35/13-98F 15 Grafton Street,
(Chevy Chase Village Historic District)

HISTORIC PRESERVATION COMMISSION STAFF REPORT

Address: 15 Grafton Street Meeting Date: 6/24/98
Resource: Chevy Chase Village Historic District Review: HAWP (RETROACTIVE)
Case Number: 35/13-98F Tax Credit: No
Public Notice: 6/10/98 Report Date: 6/17/98
Applicant: David Cox (Michael Sullivan, Agent) Staff: Robin D. Ziek
PROPOSAL: Front Porch RECOMMENDATIONS: APPROVAL

1/8" = 1'-0"
B
4
EAST ELEVATION

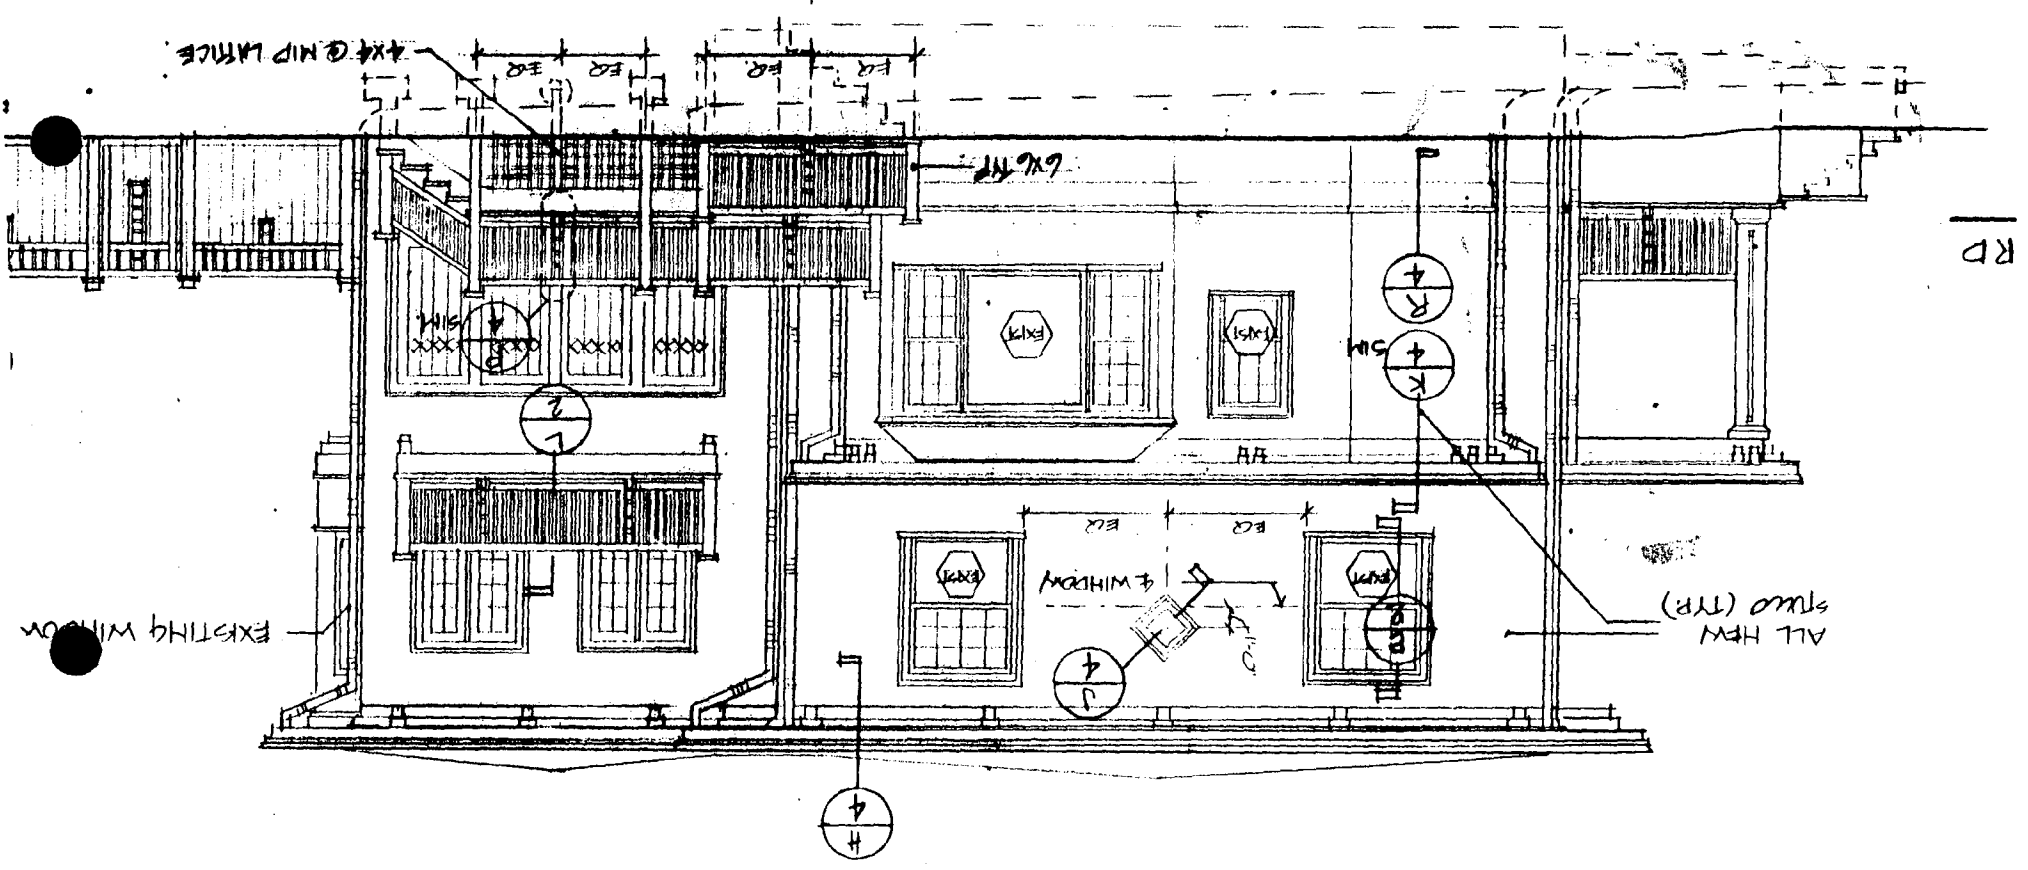
I wonder if the LAP has come to any consensus on the project at 15 Grafton Street? I did speak with the owner who pointed out that the note on the drawings refers to their original intention to remove all of the existing stucco and install all new stucco. He informed me that they would have installed smooth stucco instead of the pebble-dash. This was additional information to me, as I had assumed that the note on the drawing referred to repairing the existing stucco, but it clearly says "new stucco - typ". This does seem to support his contention that he had made a decision to change the stucco at the time of the original building permit application.

After careful review of the documents regarding the recent work which was performed on your house and after consultation with the Chevy Chase Village Local Advisory Panel, it is staff's opinion that you will not need to come back to the Historic Preservation Commission (HPC) for approval of the new clapboard siding on the first floor, front elevation of 15 Grafton Street.

A
4
SOUTH ELEVATION
 $\frac{1}{8}'' = 1'-0''$

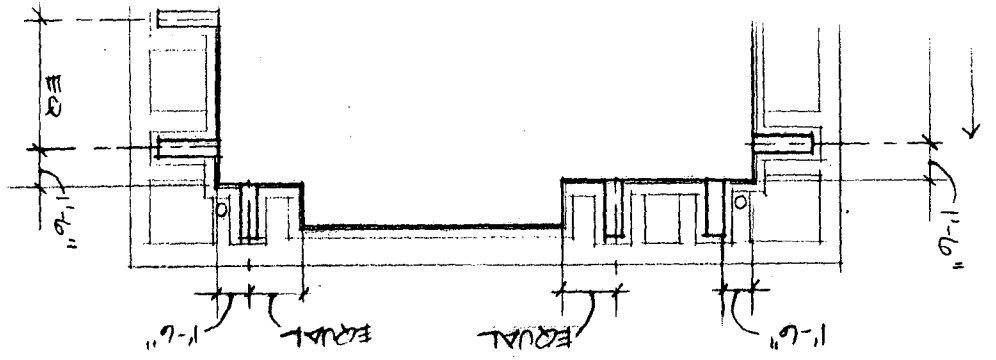
The applicant proposes to complete construction of the full-width front porch which utilizes a composite wood column and a wood rail and picket system. In addition, the front doors would be replaced with two new doors with a single transom over the opening. The new doors and the transom above include a diamond pattern in the glass.

This proposed design is compatible with the historic district and with the resource. The design elements are all consistent with the architectural style of the house without being replicative of anything particular detail in the house. The front porch materials are wood, which will complement the wood trim and brackets in the original structure. The proposed new doorway is symmetrical, but maintains the existing opening.

Staff recommends that the Commission find this proposal consistent with the purposes of Chapter 24A-8(b)2:
